## ADDENDUM NO.5

### LOWER POPLAR WATER RECLAMATION FACILITY INFLUENT PUMP STATION IMPROVEMENTS

#### MACON WATER AUTHORITY MACON, GEORGIA

**9 ARMORED EDGE**  
09-S301 SCALE: 3" = 1'-0"

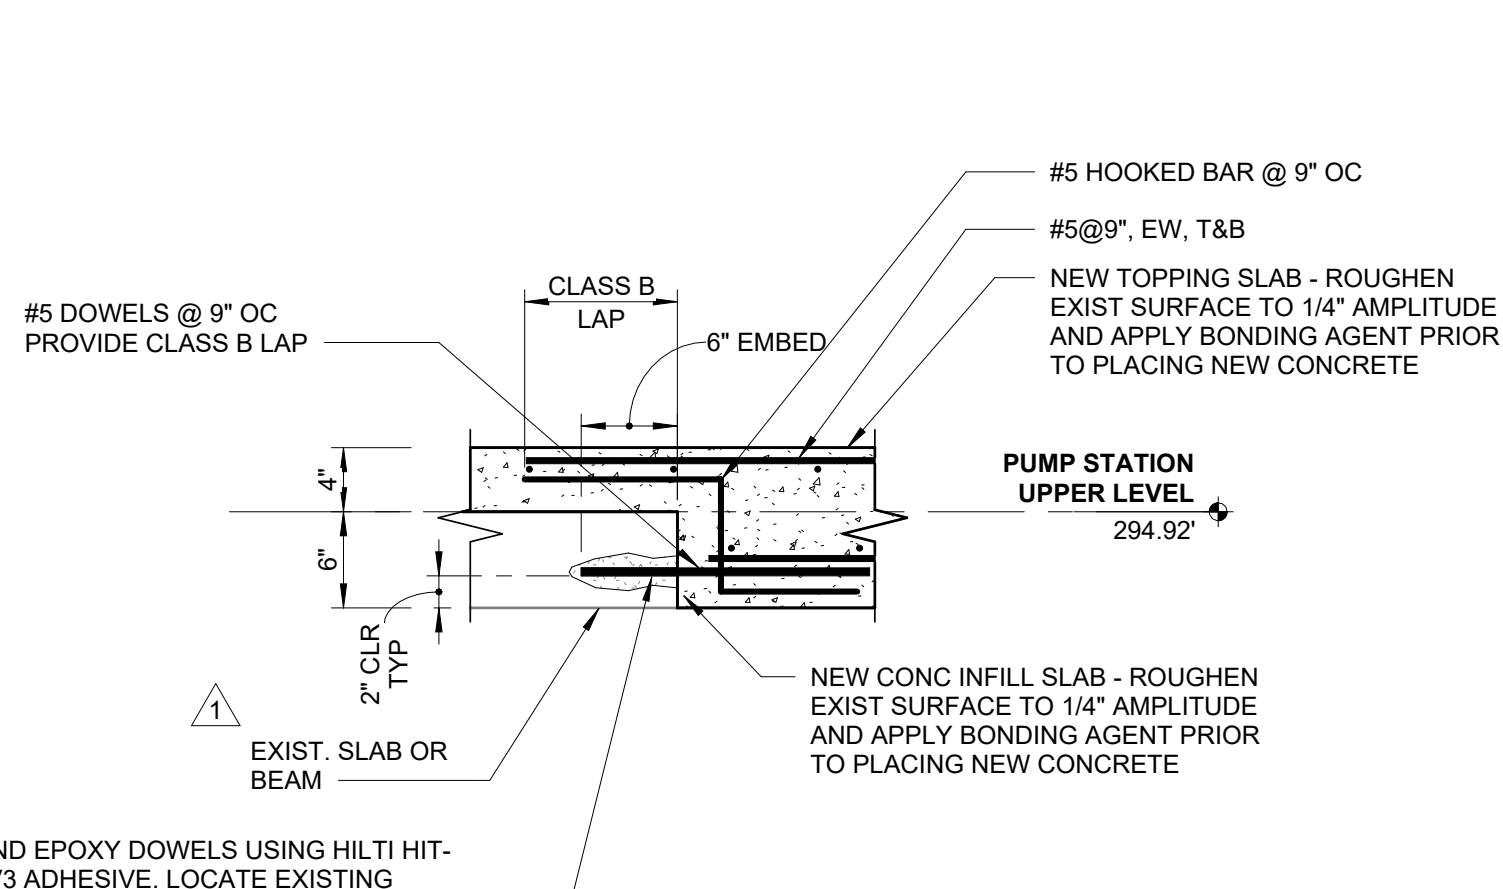
12.	Q:	Do the disconnects for the AC units in the e-houses come with the units? Please confirm.
	R:	Yes.
13.	Q:	Can you please confirm the size, quantity, location for the checkered plate / armor edge detail 9/09-S301.
	R:	See Addendum 2

**5 STEEL LINTEL**  
09-S301 SCALE: 3/4" = 1'-0"

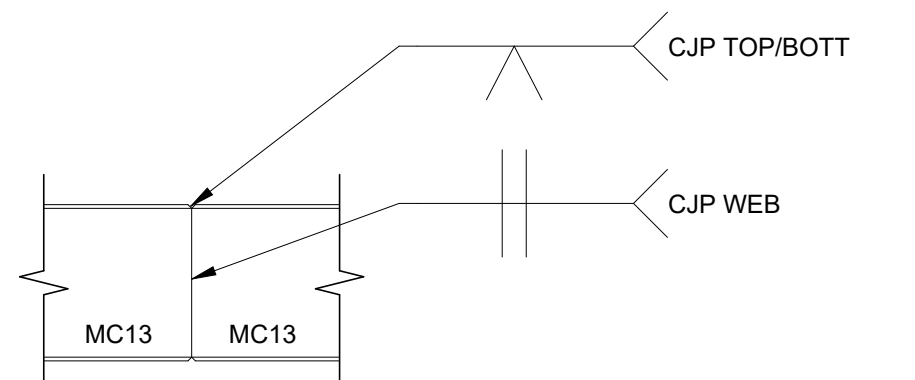
14.	Q:	Are the lintels on detail 5/09-S301 supposed to be steel or stainless steel?
	R:	Stainless Steel. See Addendum No.5
15.	Q:	Are the lintels on detail 2/09-S302 supposed to be steel or stainless steel?
	R:	Stainless Steel. See Addendum No. 5

**1 GATE OPENINGS**  
 09-S302 SCALE: 1/4" = 1'-0"

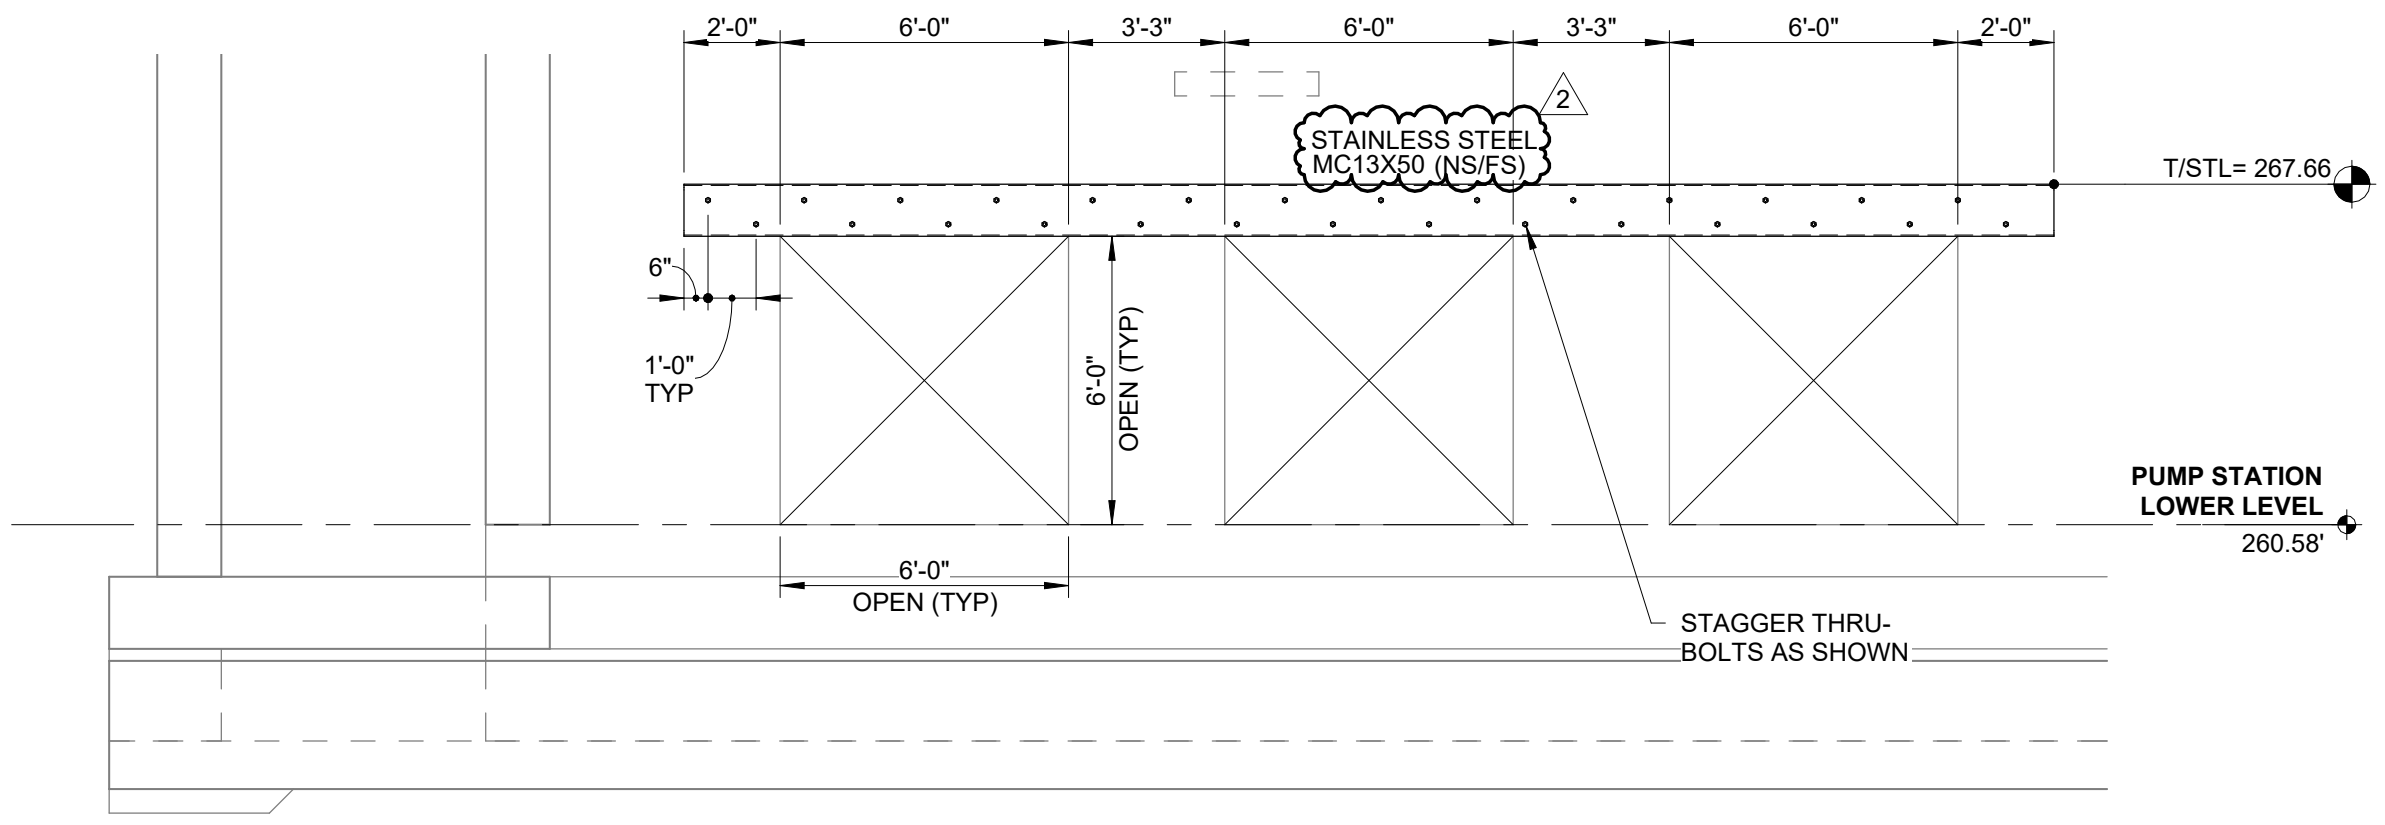
16.	Q:	For the new hatches on detail 1/ 09-S302, are new embed angles in the concrete required?
	R:	No.
17.	Q:	There are multiple places on the drawings that indicate the eHouse MCC's are 1200A. However, on page 09-E605, it shows 1600A. Please clarify.
	R:	Fused Disconnects and MCC's to be 1200A. See Addendum
